# PLANNING COMMISSION STAFF REPORT

## ARBORSIDE – DESIGN PLAN

**REQUEST:** Requesting approval from the Clermont County Planning Commission for Arborside – Design Plan

Per the review of Arborside – Design Plan, the development will follow all requirements pertaining to Article V of the *Clermont County Subdivision Regulations* based on conditions noted in the Design Plan Comment Review Meeting held on April 27, 2026. The proposed subdivision is an expected development and complements the land uses of the surrounding area. There are a number of conditions that must be met regarding the development. Departmental comments are below and the applicant and developer are aware of the requirements in order for this subdivision to be constructed.

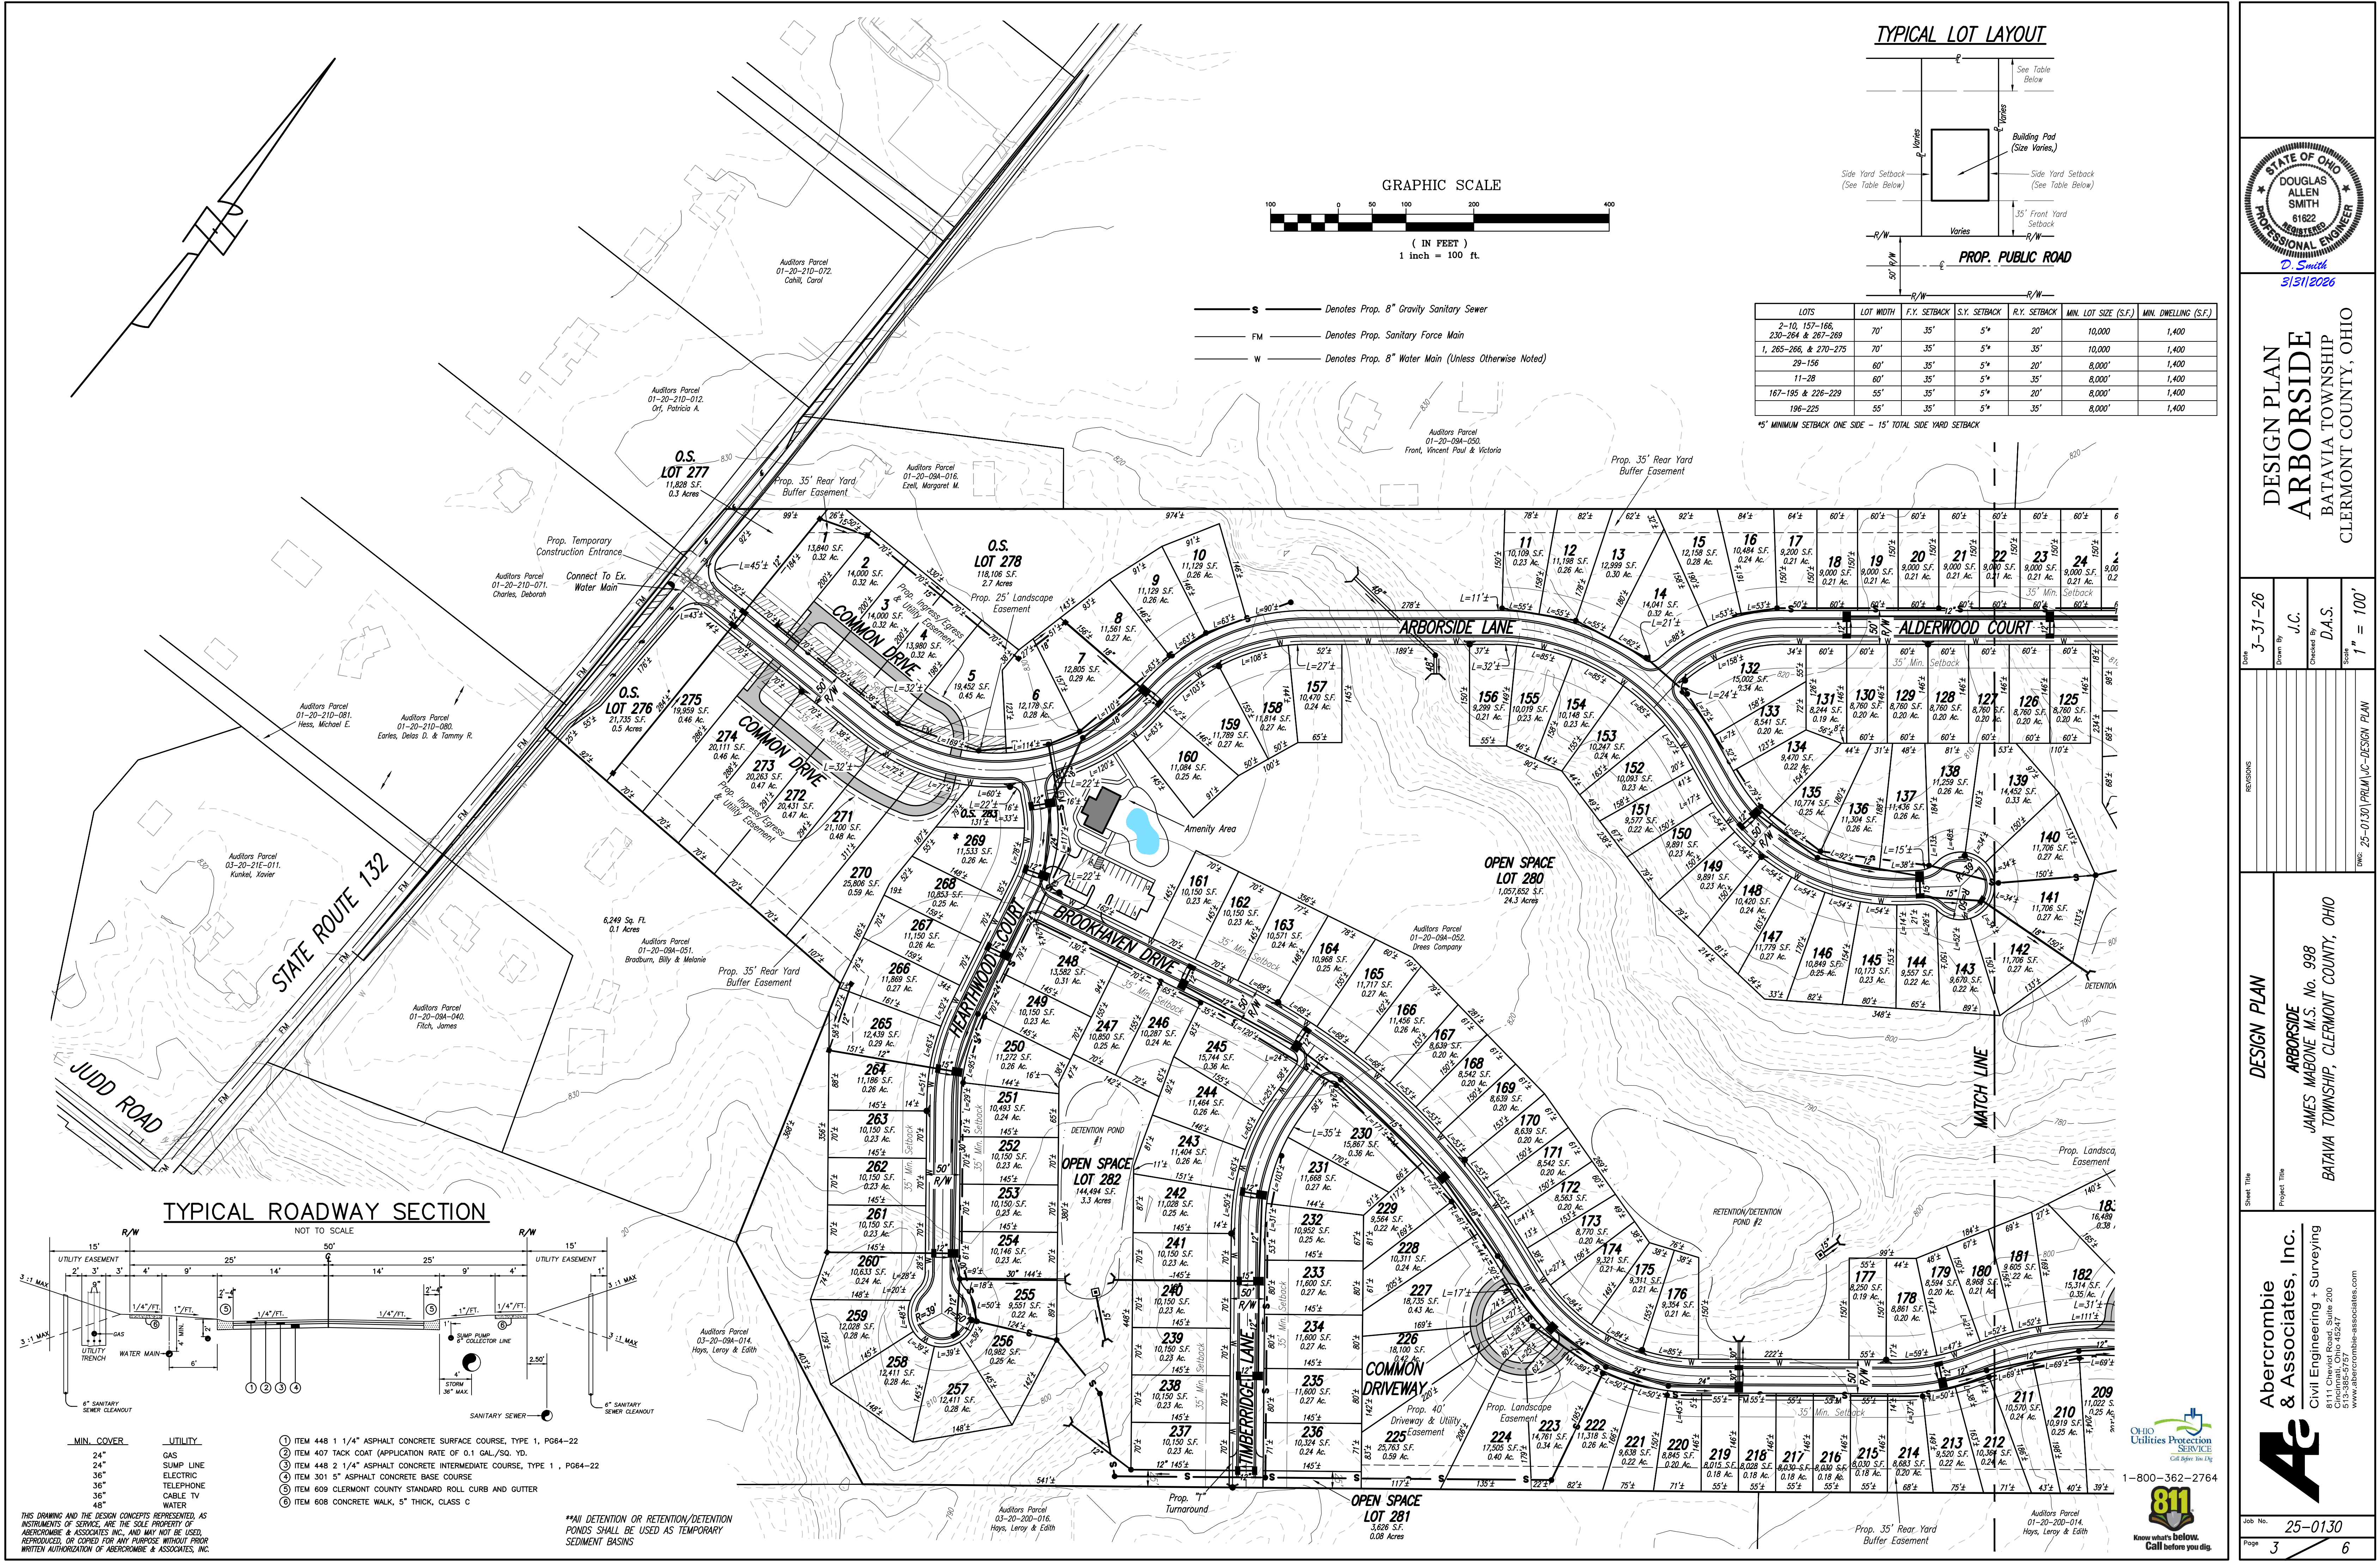
10. On Sheet 4, are you intending for the roadway between lots 26 and 27 to be extended in the future? If so, please have the water main and sanitary sewer able to be extended from a tee and cap or have it fixed with a

11. On sheet 4, the manhole between lots 113 and 193 will need to be outside of the flow paths of storm lines.

TYPICAL LOT LAYOUT

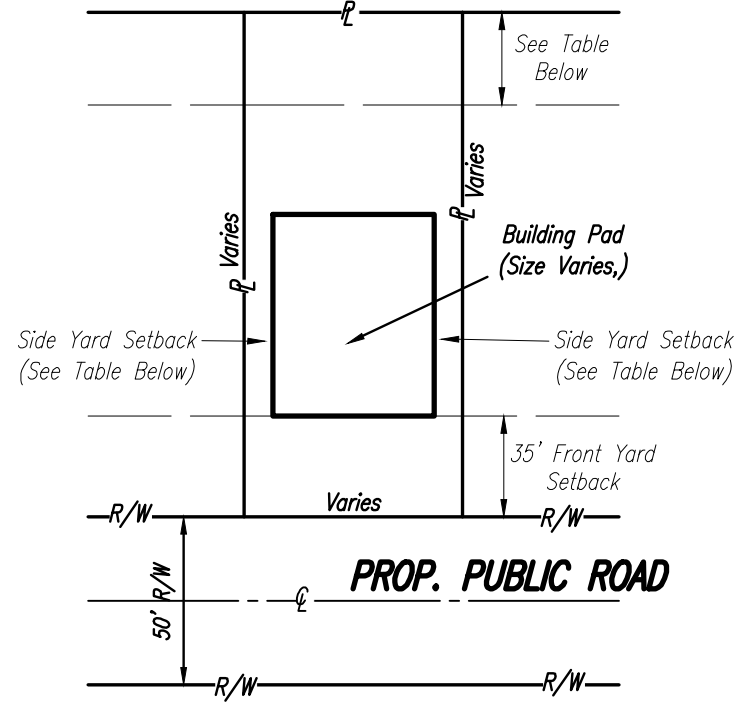
1. Cover Sheet – Development Data: The Auditor's Parcel numbers shown do not appear to match the actual project location. Please verify.
2. Typical Lot Layout Note: Please ensure the "Typical Lot Layout" note clearly states that all lots must provide positive drainage away from each structure toward the property lines at the required minimum slope per building code. Additionally, ensure compliance with Article 7.0, Section 700.1, of the WMSC regulations, which requires a minimum ten (10) foot wide drainage easement for all stormwater conveyance systems, including drainage swales between lots.

Job No. 25-0130  
Page 3 6

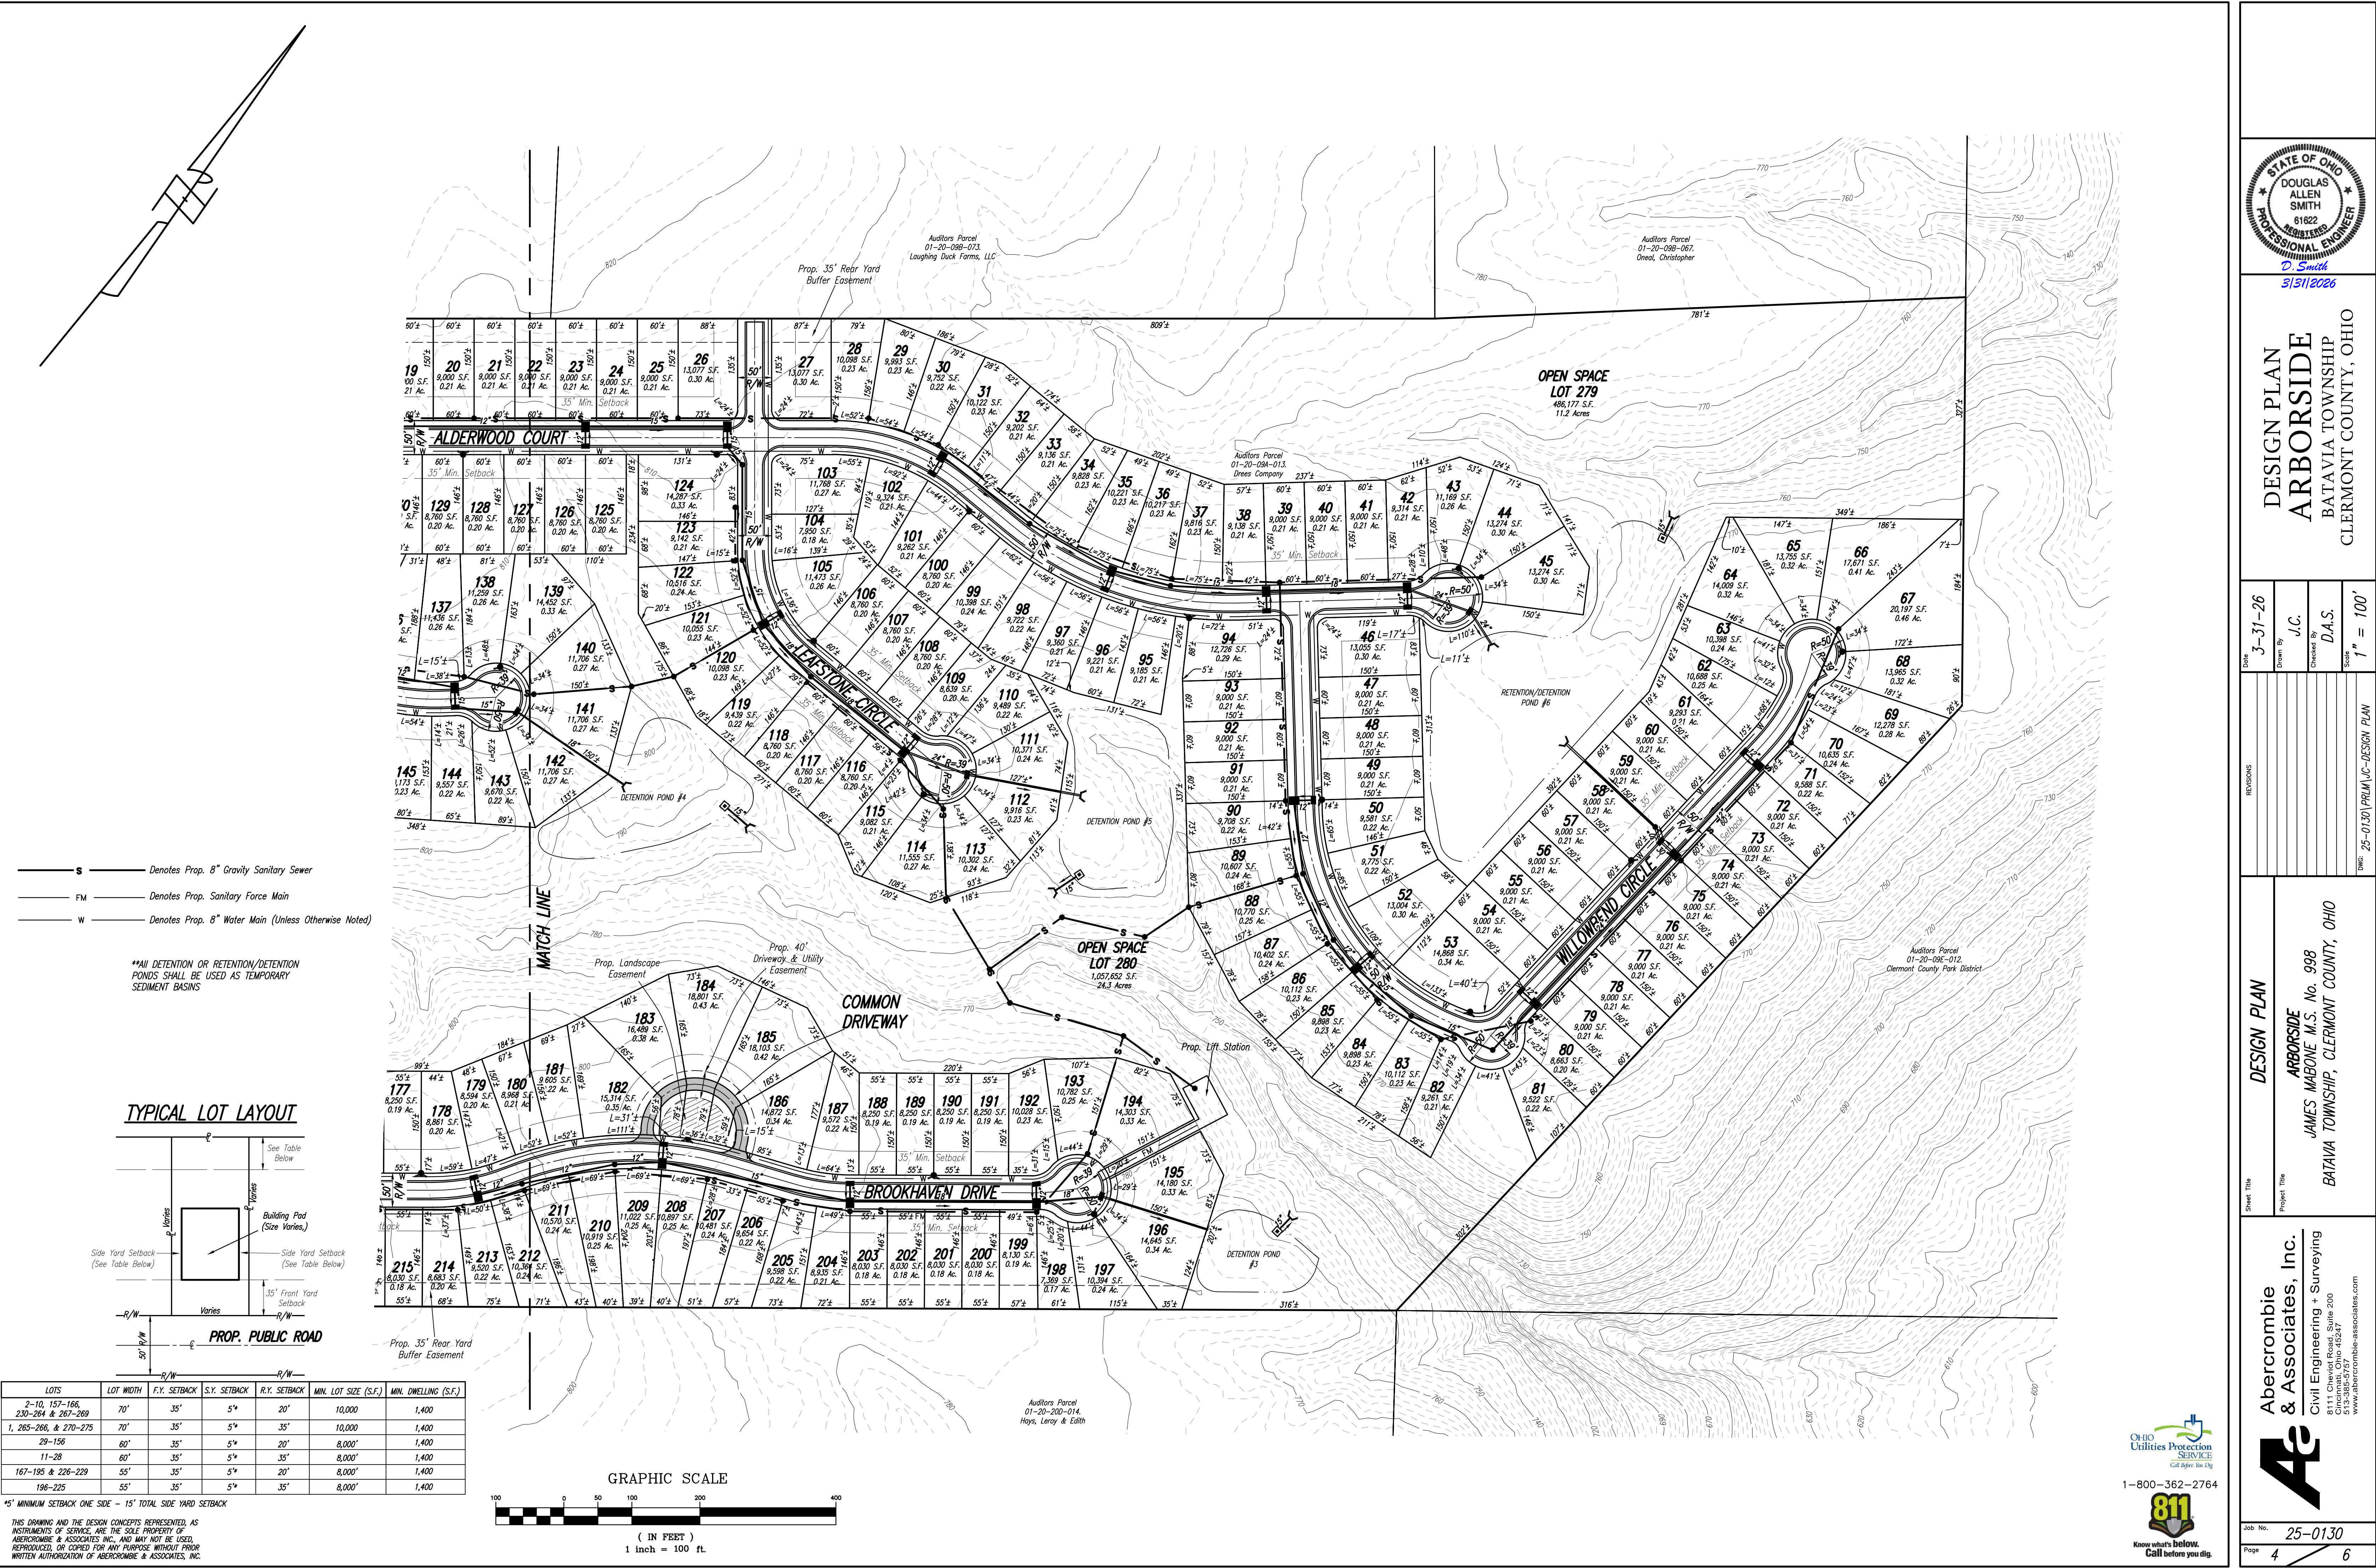
1. On all utility sheets show valves for the water mains.
2. On Sheet 3, show the tie-in method and location clearly with labels. Include any necessary valves.

3. On Sheet 3, show stationing on roadways and apply stationing labels to fire hydrants.
4. On Sheet 3, is there a manhole at lot 15? If not, all sanitary sewers are to end with manholes.

5. On Sheet 3, on open space lot 282 the sanitary sewer crosses over a drainage path. Is the rim elevation outside of storm elevations?
6. On Sheet 3, lots 1-5 and lots 270-275 the proposed ingress/egress and utility easement will need to say "public utility easement" since it includes public utilities. This applies in all locations where you have public utilities within the said easement.

7. On Sheet 3, between lots 256 and 238, the storm drain will need to be extended beyond the line of the sanitary sewer to reduce scour potential over the sanitary sewer.

8. On Sheet 3, show the laterals for lots 257 through 260 and make sure they follow CCWRD standards.
9. On Sheet 4, move the manhole in the knuckle between lots 81 and 82 outside of the pavement. Keep manholes outside of the pavement per our regulations.
